November 30, 2021

Re: Comments on I-495 & I-270 Managed Lane Study Supplemental Draft Environmental Impact Statement and Updated Draft Section 4(f) Evaluation

Figure 1: Northbound Inner Loop Throughput 5-6 p.m. – 2017 from DEIS, 2045 from SDEIS

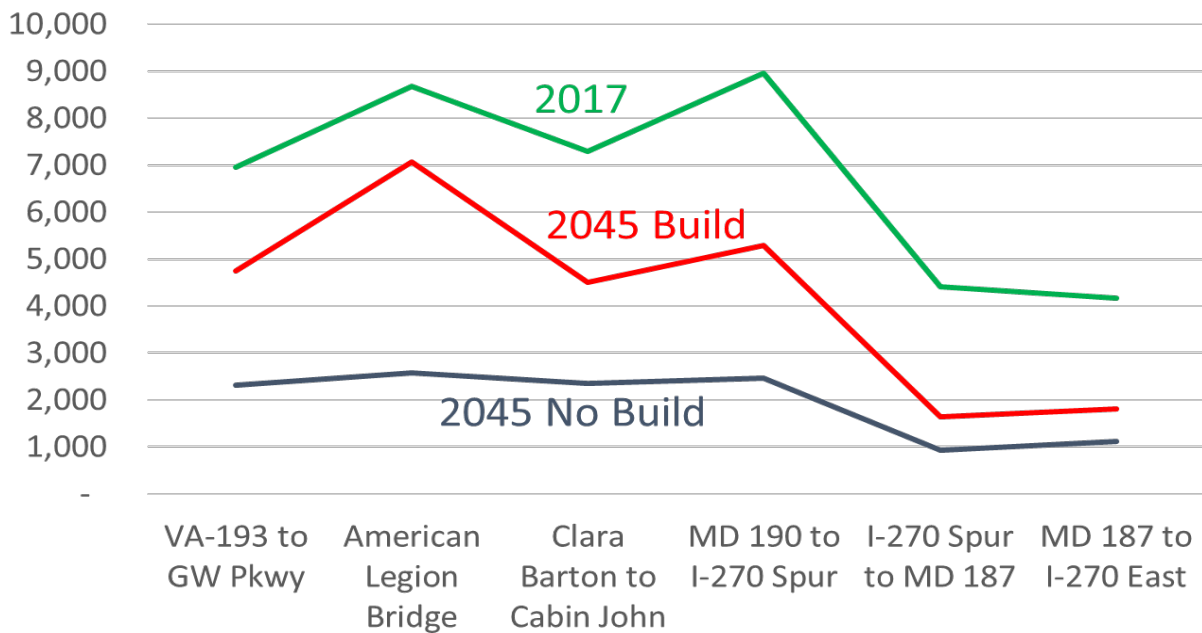
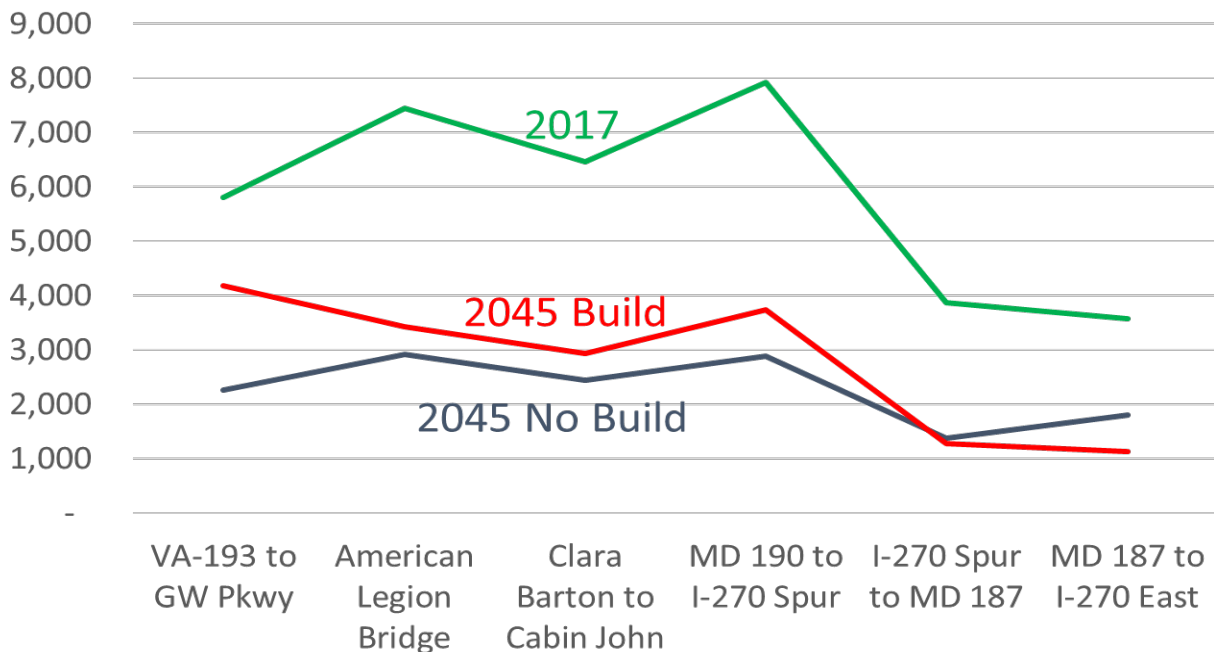
There is no real-world rationale for future throughput being significantly lower than today. Without widening, throughput will be very similar to today because the road is already congested. With widening, throughput also will be very similar to today because traffic flow will be metered by the downstream bottlenecks. The SDEIS compares two sets of wrong 2045 throughput numbers and presents the difference between them as a performance metric. This is invalid.

In the DEIS, the Inner Loop afternoon peak hour volume (5-6 p.m.) on the American Legion Bridge is reported to be 8,760 vehicles per hour. This segment has 5 travel lanes today, so the average volume is 1752 vehicles per lane per hour. In the SDEIS future Build model, 2 managed lanes are added so there would be a total of 7 lanes. The SDEIS reports the throughput as only 3,430 vehicles in the 6-7 p.m. hour, i.e., less than 500 vehicles per lane per hour – less than the traffic volumes on city streets interrupted by traffic signals. This is obviously wrong.

Although the throughput numbers are wrong, they are illustrative of a fatal flaw in the preferred alternative design. For the express toll lanes to operate effectively, the traffic in them must be able to merge back into the general-purpose lanes at the northern terminus. The very low throughput volumes shown in Figures 1 and 2 show that the VISSIM model is suggesting that this is impossible, and furthermore, that the merge point will cause traffic to spill back for miles in both the general-purpose lanes and the managed lanes.

Figure 3: Preferred Alternative 2045 Inner Loop American Legion Bridge Demand, Throughput and Cumulative Unserved Demand (Queue) in the Afternoon Peak Period

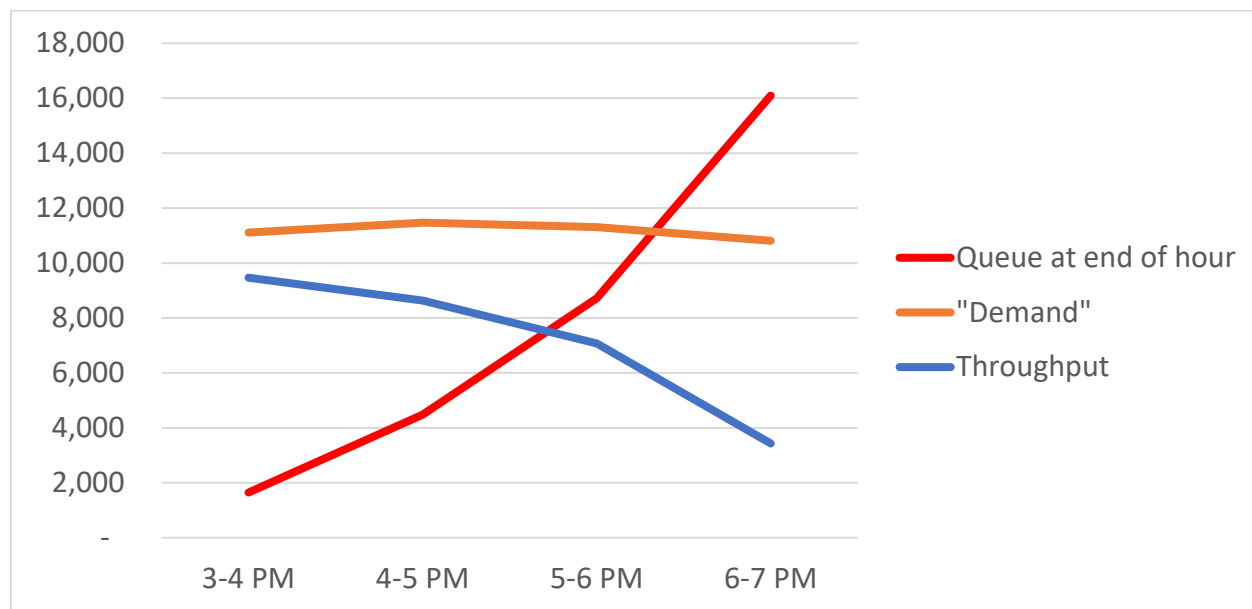
The VISSIM model is overwhelmed by the “garbage in” “demand” and translates it into unrealistically- low throughput. The SDEIS calls the difference between “demand” and “throughput” “demand unserved.” During the afternoon peak period (3 -7 p.m.) in the inner loop there is unserved demand in each of the four hours, and the VISSIM model queue becomes longer and longer through 7 p.m. This queue of cumulative unserved demand is not reported in the SDEIS but is easily calculated from the demand and throughput numbers. Figure 3 shows demand, throughput, and cumulative unserved demand.

Assuming that there is no traffic backed up at the beginning of the simulation (3 p.m.), the traffic backup (queue) grows exponentially over the 4 hours of the afternoon simulation to over 16,000 vehicles at 7 p.m. Clearing this accumulated queue in VISSIM would require many hours of additional simulation

Figure 4: Preferred Alternative 2045 Inner Loop American Legion Bridge Demand, Throughput and Cumulative Unserved Demand (Queue) in the Afternoon Peak Period Illustrative Extension of VISSIM Simulation

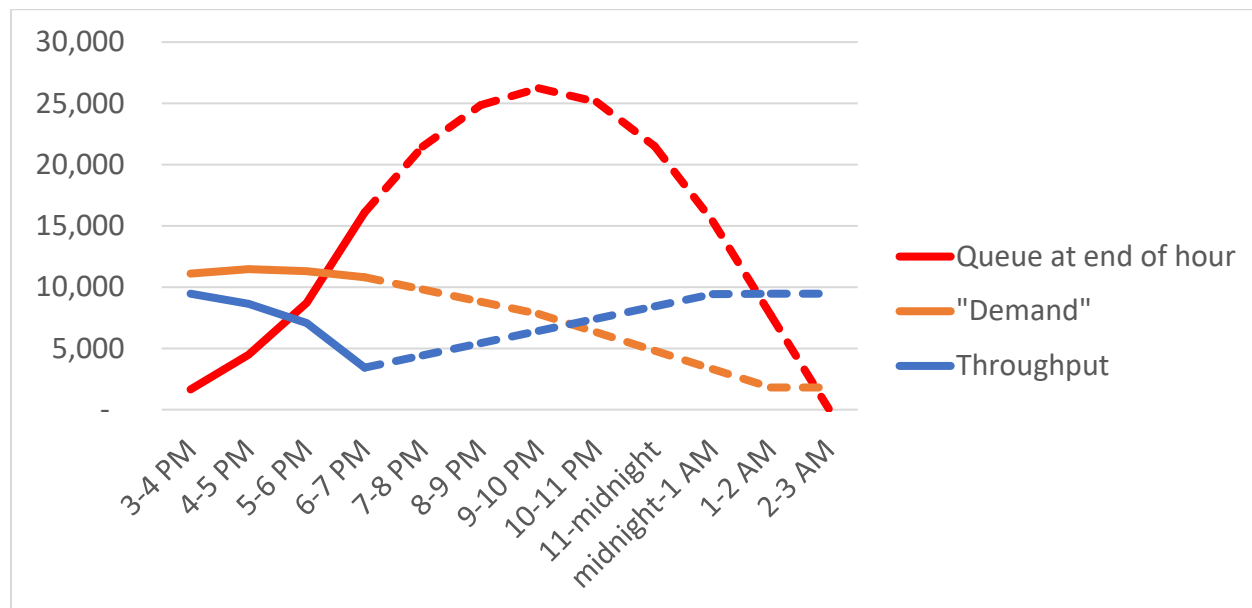
Figure 4 illustrates what the VISSIM model might show if the simulation were extended far enough to eliminate the queue. As long as “demand” exceeds throughput the queue increases. In this illustration, the maximum queue is not reached until 10 p.m. Only after 10 p.m. does throughput exceed “demand” allowing the queue length to shorten and finally be eliminated after 3 a.m.

This illustration is not realistic or the real world but is representative of what the VISSIM model would do if the simulation were extended overnight. Therefore, ending the simulation at 7 p.m. is arbitrary and greatly underreports the congestion problems in the VISSIM model.

Figure 6: Impossible Traffic Forecasts in MWCOG 2040 No Build Afternoon Peak Period (Segments with Volume/Capacity Greater than 1.1 Shown in Red)⁵⁴

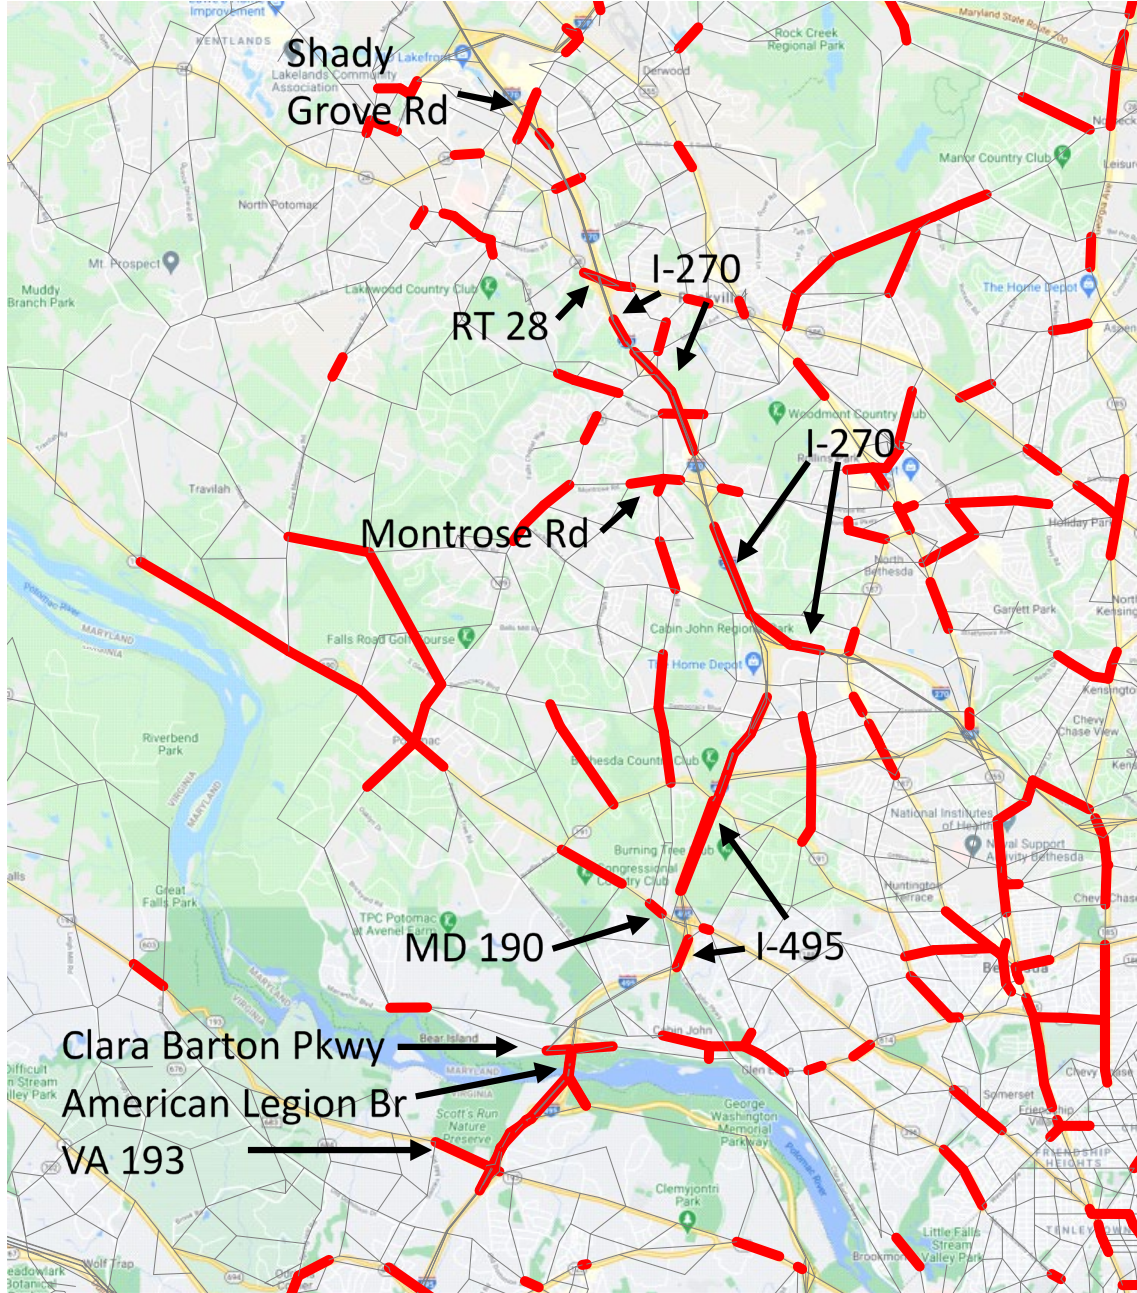
In the DEIS, many segments of I-495, I-270 and other roads are loaded with v/c greater than 1.1 (Figure 6). Horowitz admonishes that the DEIS modeling should not be published with v/c > 1.1. Therefore, these model results should not be used for planning purposes. The DEIS not only does publish these modeling results and uses them for planning, but even goes so far as to represent these over-capacity assignments as a performance measure. This claim is false and is rebutted in the Appendix B of this report section (Section II.F).

Figure 7: Wildly Impossible Potomac Bridge Traffic Forecasts in MWCOG 2040 No Build Morning and Afternoon Peak Periods

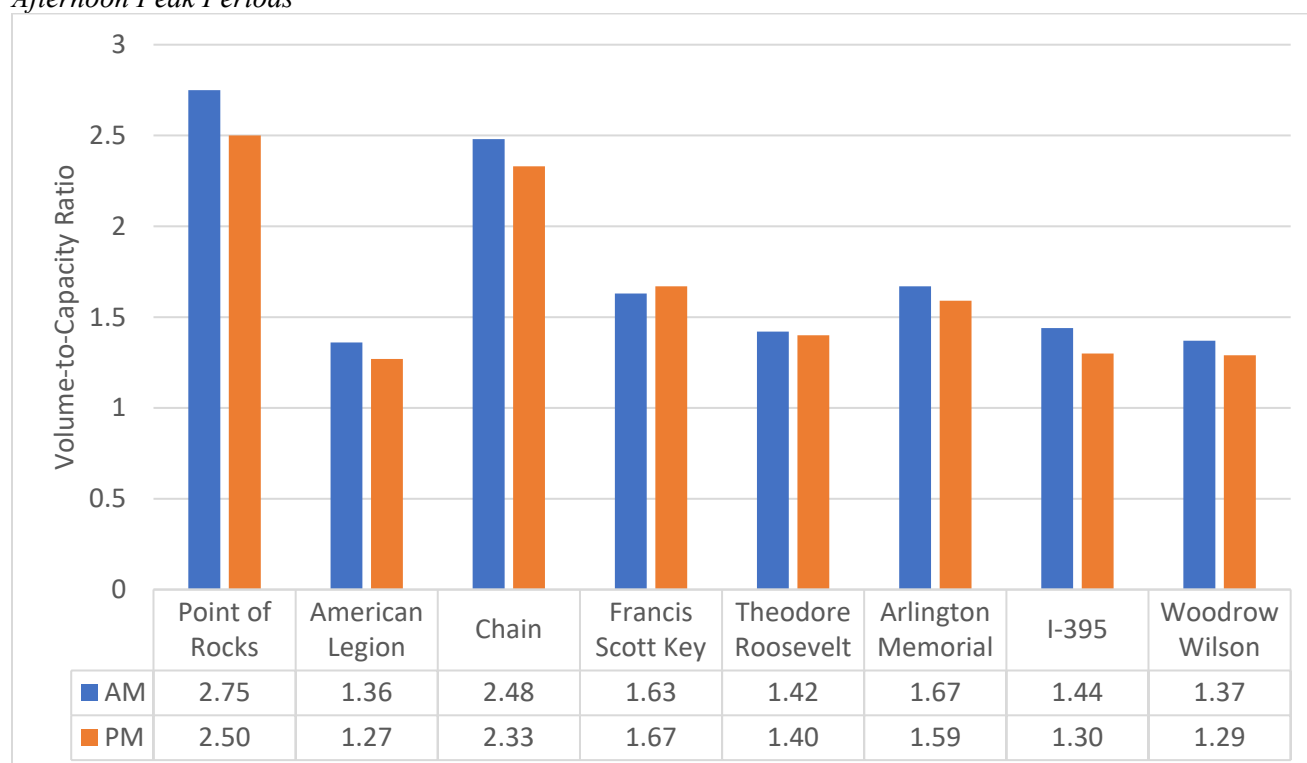
In the DEIS 2040 no build model, MWCOG morning and afternoon peak period traffic volumes for all Potomac River bridge crossings are ridiculously high (Figure 7). All greatly exceed the 1.1 volume-to-capacity ratio threshold, and range as high as 2.75, i.e., the bridge traffic volume is 275% of the highest possible volume.

Figure 12: 2040 No Build Regional Afternoon Peak Period VHD – Road Segments with Possible $v/c \leq 1.0$ vs. Impossible $v/c > 1.0$

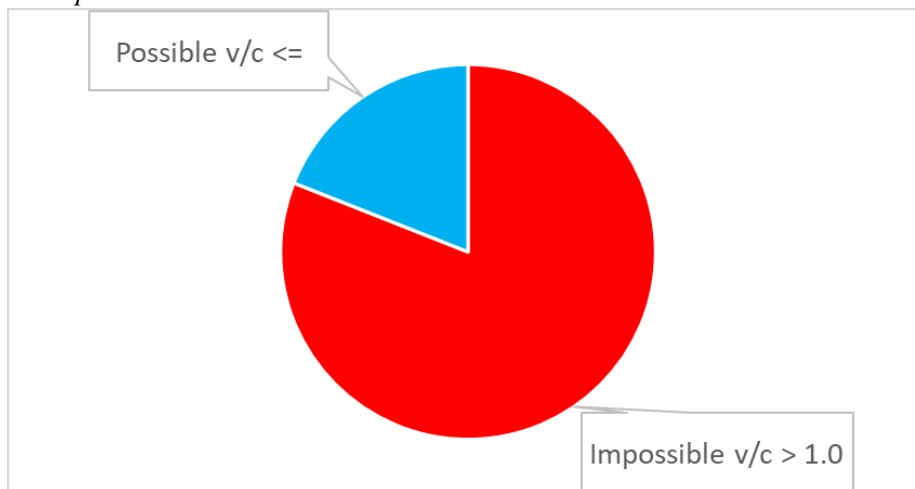
As shown in Figure 12, most (81%) of regional afternoon peak period VHD in the 2040 no build modeling is from impossible assignments with volume-to-capacity ratio exceeding 1.0. The exponential increases in modeled delay as a function of V/C makes MWCOG model VHD more of a metric of model errors than a metric of real-world performance.

Figure 13: DEIS Vehicle Minutes of Delay Per Capita for Montgomery and Prince George's Counties⁶⁵

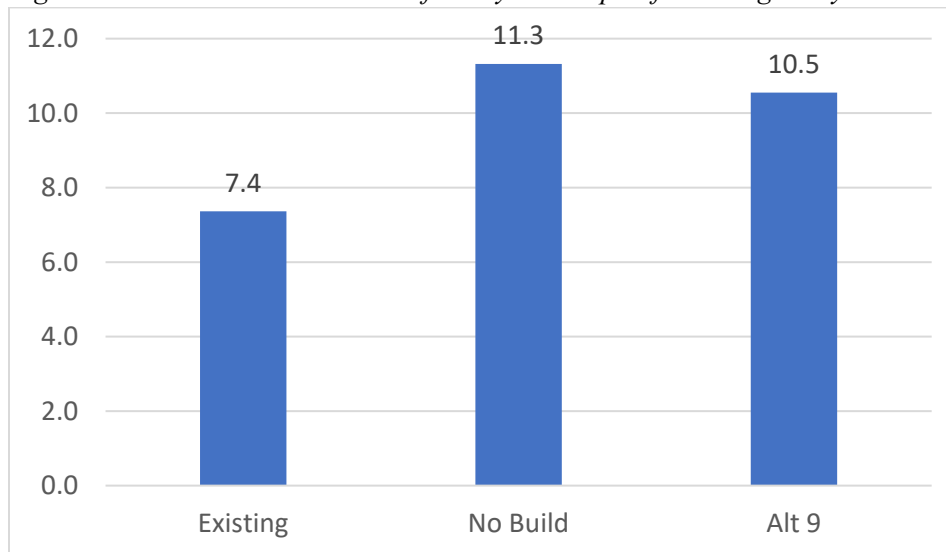
The DEIS VHD calculations are invalid. However, even if they were valid, they do not provide a compelling case for the proposed managed lanes Project. Figure 13 takes the DEIS VHD numbers for a combination of Montgomery and Prince George's Counties and divides by current and 2040 population so the alternatives can be compared on a per capita basis.

Figure A1: Maryland DEIS Daily Traffic Data and Forecasts (Tables 3-1 and 3-2)

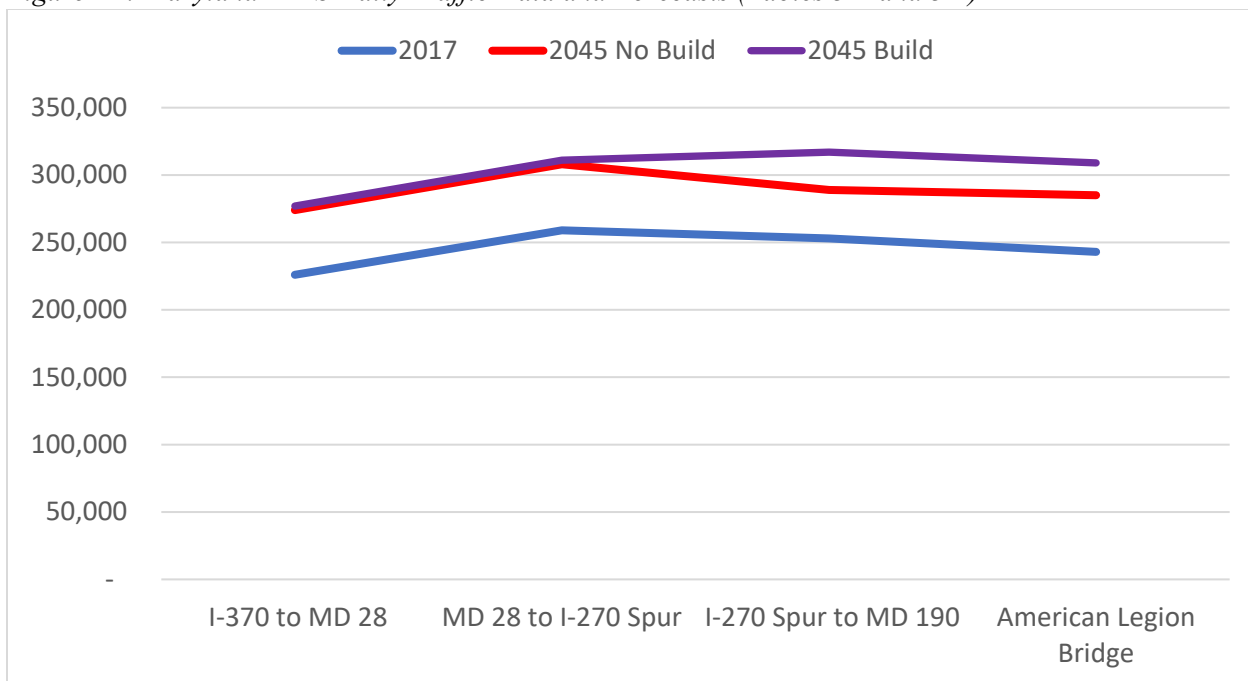
Figure A1 shows SDEIS daily traffic data and forecasts for I-495 and I-270. The SDEIS forecasts significant traffic growth in the 2045 no build alternative and only slightly higher growth for the build alternative.

Figure ES-1: Alternative 9 – Phase 1 South Typical Sections (HOT Managed Lanes Shown in Yellow)

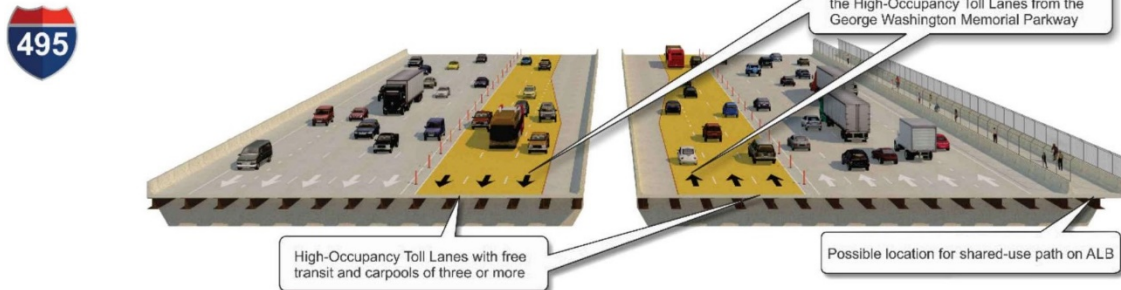
- The Project has fundamentally changed so many times (including its footprint, phasing, and procurement type from fixed price to progressive predevelopment public-private partnership) that the public cannot understand what is going on, let alone which description is accurate. The SDEIS does little to clarify such issues and if anything muddles them even more by trying to

simultaneously exclude and include I-495 east of the eastern spur from the preferred alternative plan. The purpose of the NEPA process is to disclose information so the public and other agencies can make informed comments and decisions. This awkward and hastily prepared add-on to the DEIS does not achieve those ends.
